# **Heavy minerals mine — Beenup**

**Mineral Deposits Limited**

**Report and recommendations of the  
Environmental Protection Authority**

**Environmental Protection Authority  
Bulletin 483  
December 1990**

BEENU P-DRY MILL  
 SITE DRAINAGE PLAN  
 FIGURE 1.

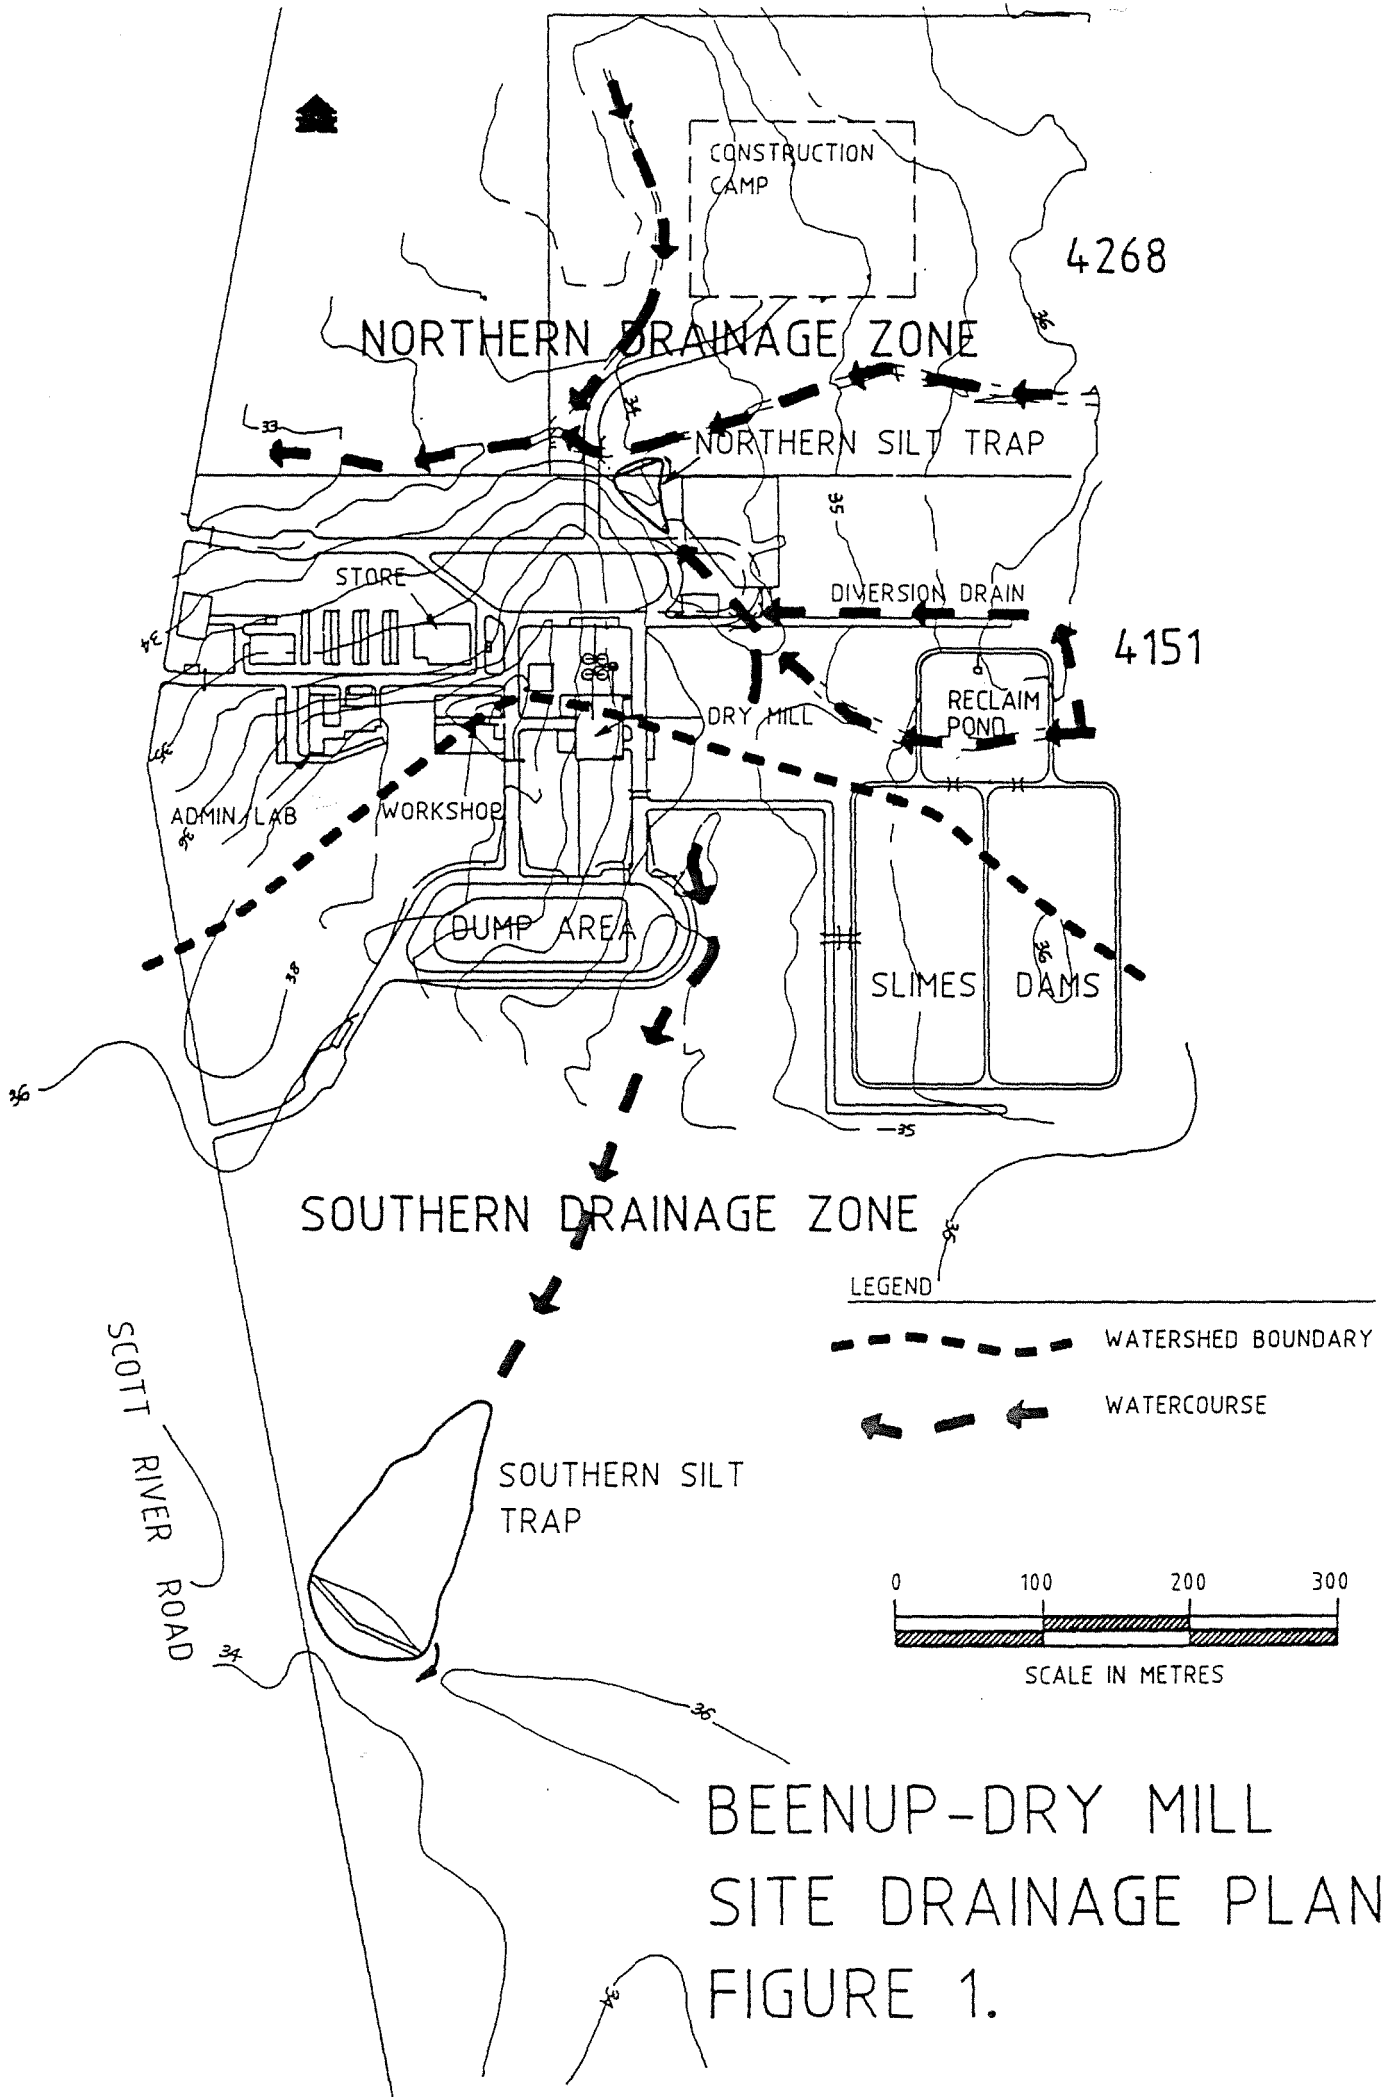
Drainage paths and catchment boundaries are shown on Figure 1. The dry mill site will be effectively divided into two drainage zones. The northern drainage zone encompasses the bulk of the dry mill site, including the administration and support buildings, the dry mill itself, the product load-out area and the temporary construction camp. The southern drainage zone includes the concentrate dump station, dump area and slimes dams. Existing drainage lines traverse the site from south-east to north-west approximately as indicated on the Site Drainage Plan.

Drainage lines including both piped underground drainage and open channel drains are shown on Figure 1.

Two main silt traps or holding dams are proposed for the dry mill site as shown on Figure 1. The northern holding dam is located between the construction camp and dry mill, whilst the southern holding dam is to be located at the south-west boundary of the site. These dams are provided to capture and settle out excess sand and silt and contain any contaminants which may result from the work areas of the dry mill site. Physical details of each dam are described in the answer to question Q110.

(See also response to Question QI01, part 3). The locations of the slimes dams within the southern drainage zone are shown on Figure 1.

FIGURE 2  
 BEENUP PROJECT  
 MINING AREA —  
 SURFACE WATER MANAGEMENT.  
 SCALE 1:10000

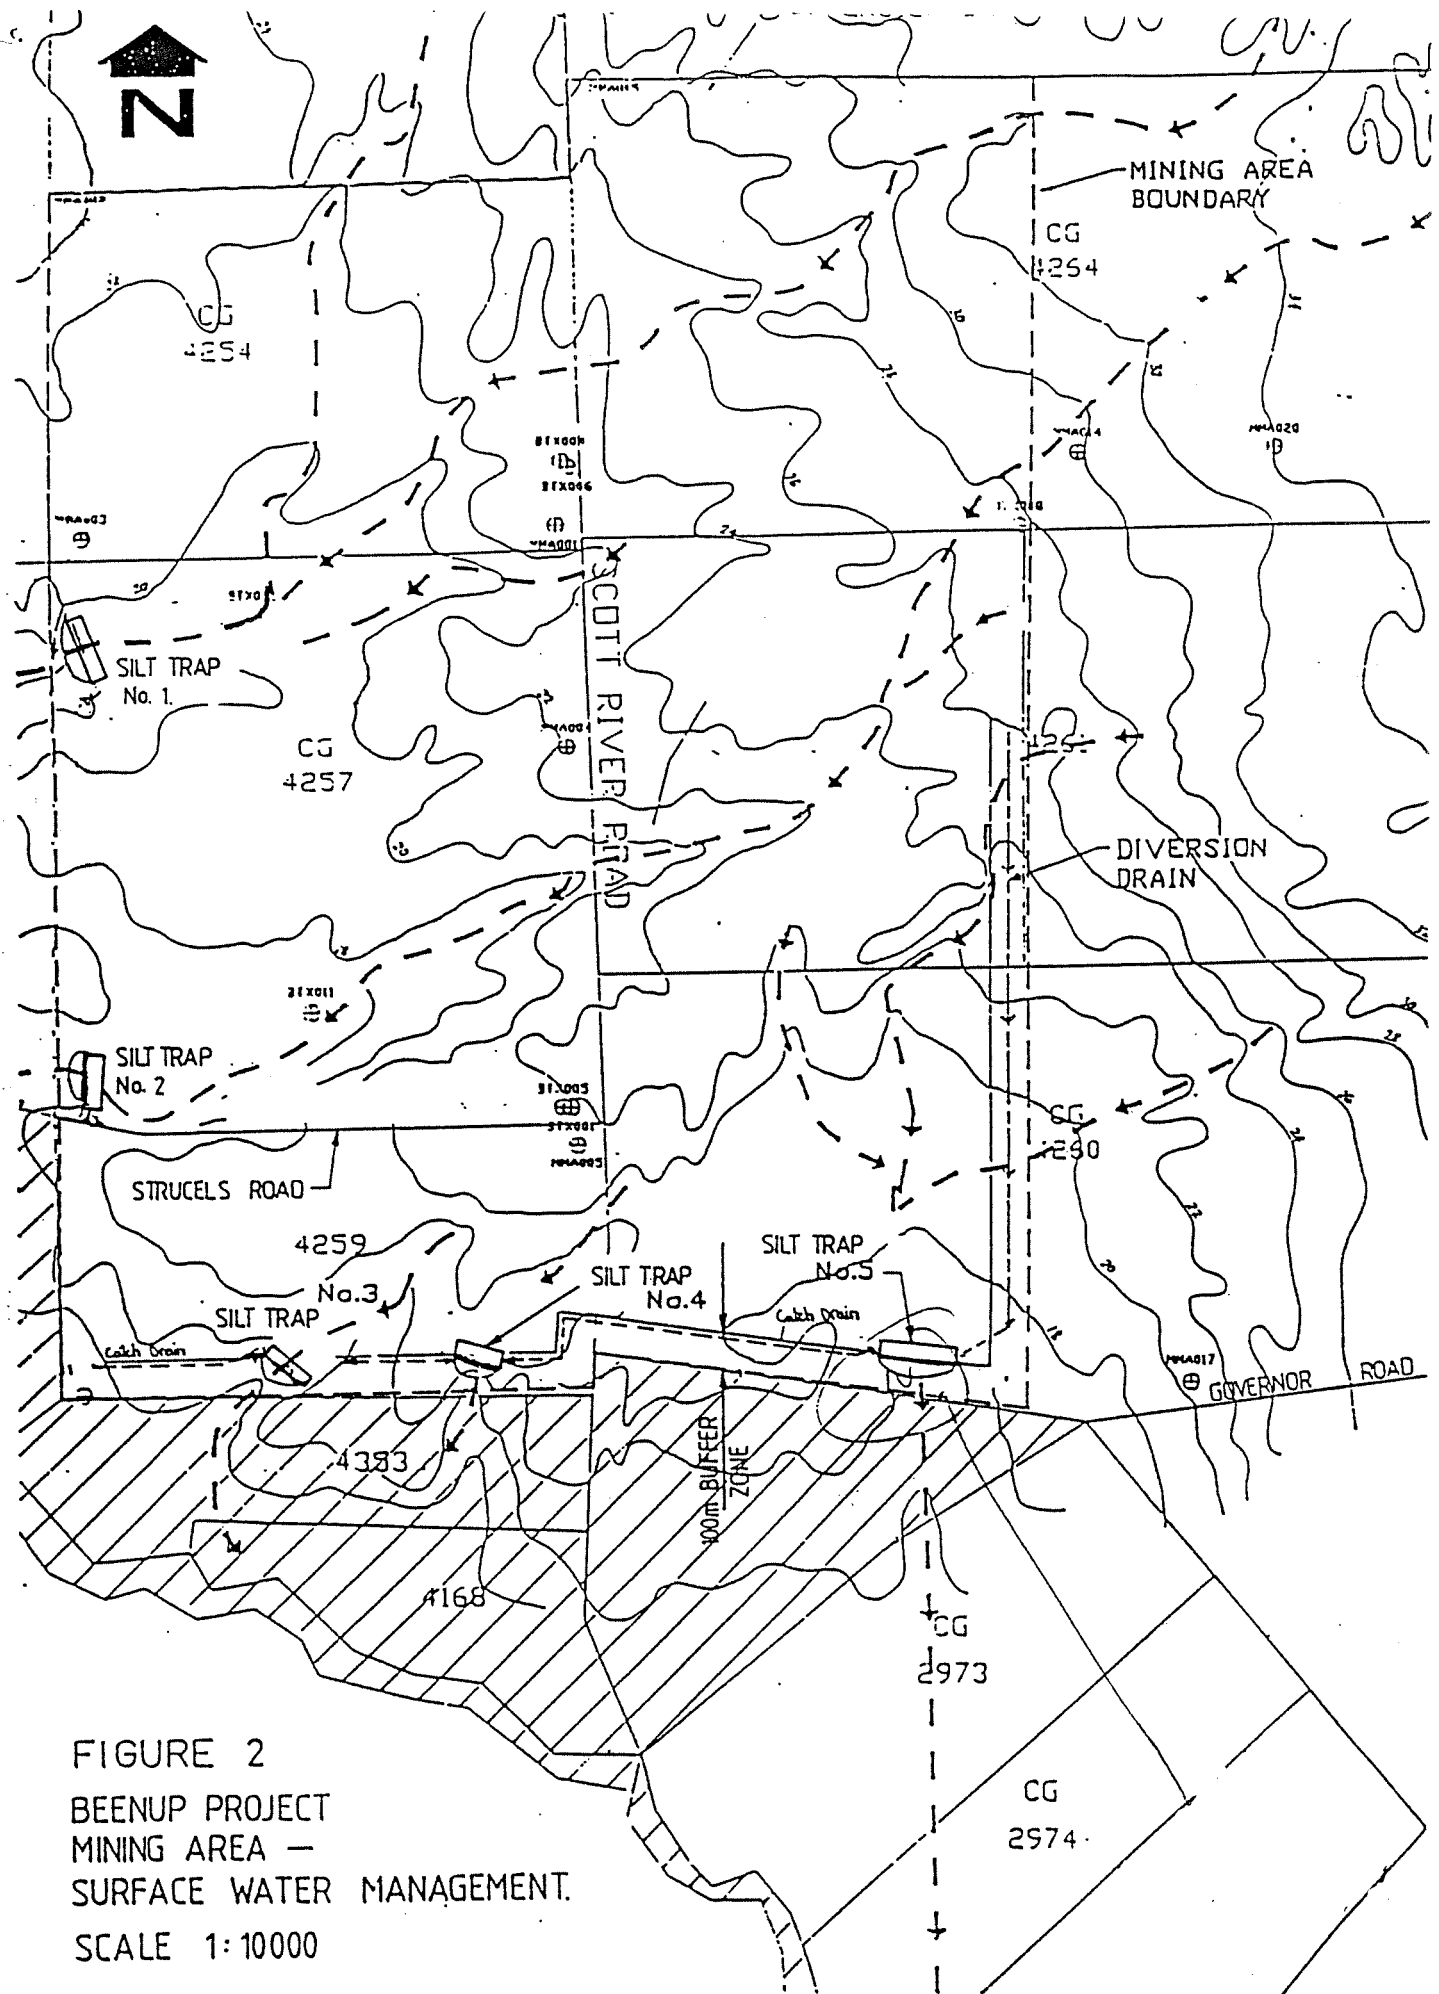
The general plan for management of surface water within the mine site is indicated on Figure 2. It can be summarized as follows: -

It is anticipated that the south-eastern channels will be constructed first and as the mine area moves north, the channels will follow. The channels will be constructed on the buffer boundary between the mining area and the neighbouring farms and/or National Park. These channels will be shallow spooned structures which will all feed into nearby silt traps as shown in Figure 2.

Figure IV-1 (Appendix IV) from the ERMP, and Figure 2 attached, shows that three main drainage systems traverse the proposed mine site at present:

TOE DETAIL - SLIMES DAM

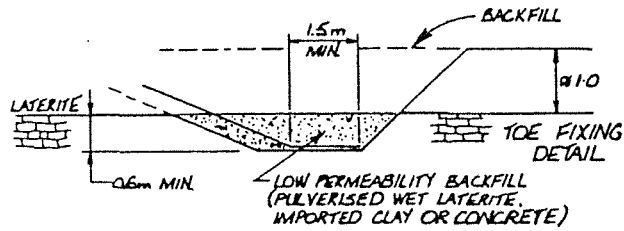
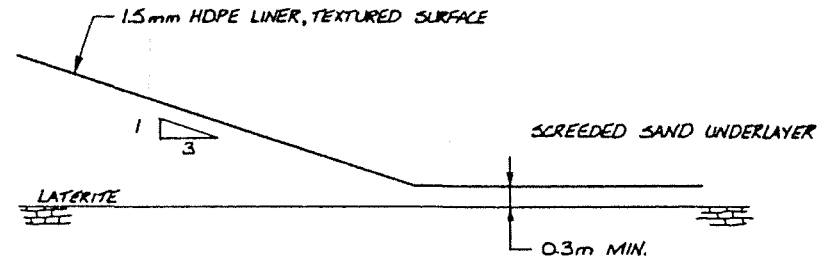
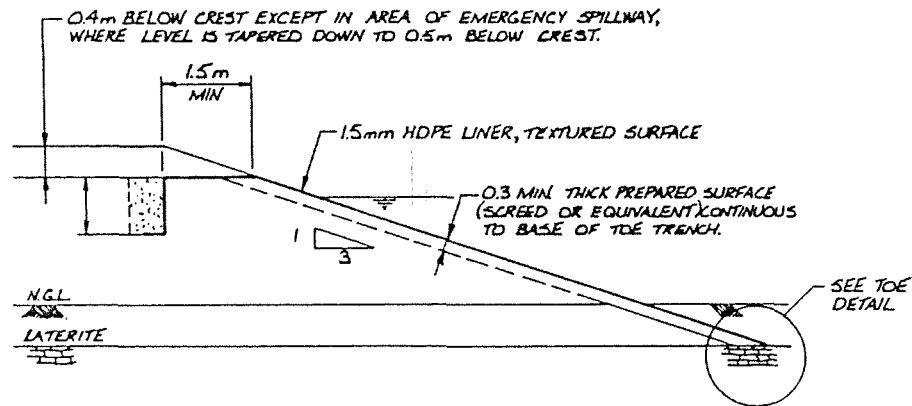
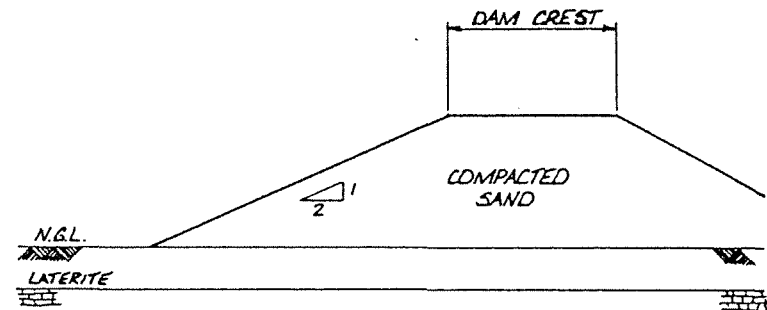
These dams will be unlined and constructed above ground by the formation of perimeter embankments. Slimes will be discharged into the dam at the southern end and supernatant water allowed to overflow into the reclaim pond at the northern end. Preliminary details of the overflow decant facilities are shown on Figure 3.

The dams are located above an extensive lateritic caprock which is located between depths of 1.5m to 3.0m below surface and has a thickness varying from 1.0 to 1.5m. A typical dam embankment profile is given on Figure 3 and shows how an impermeable membrane will be located within the embankment and extended into this caprock. This will effectively seal the slimes dams and minimize seepage into the surrounding water table as currently occurs in local farm dams. The outside slope will be stabilized by grassing to prevent the formation of scour rills.
